REMARKS

FIG. 4

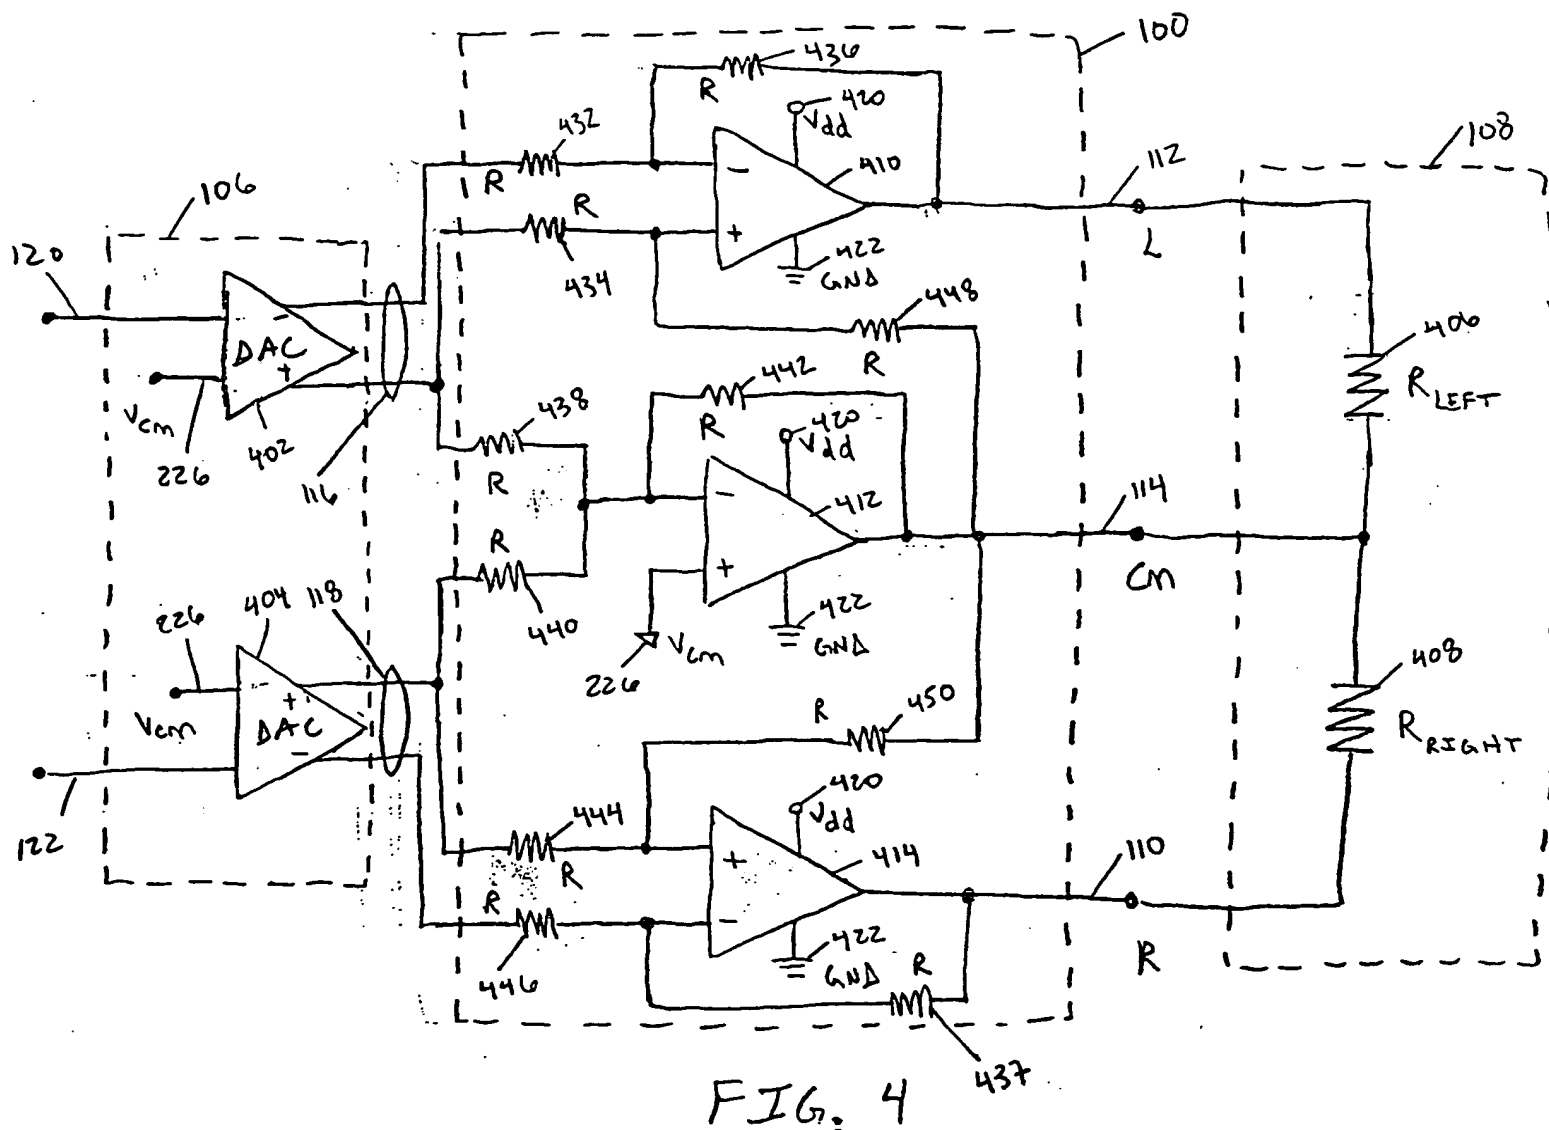
The Applicants have amended FIG. 4 to correct an inconsistency with respect to OPAMP 414. As with OPAMPs 410 and 412 and resistors 436 and 442, a resistor 437 is connected between the output of OPAMP 414 and the negative input terminal of OPAMP 414. The resistor 437 was inadvertently omitted from FIG. 4 as filed. As depicted in FIG. 4 and described in the application, the three OPAMPs 410, 412 and 414 are similarly positioned to drive the left (L) channel signal 112, the right (R) channel 110 and the common mode (CM) signal 114, respectively. [Specification, page 10, lines 11-14]. This amendment adds no new matter to the application.
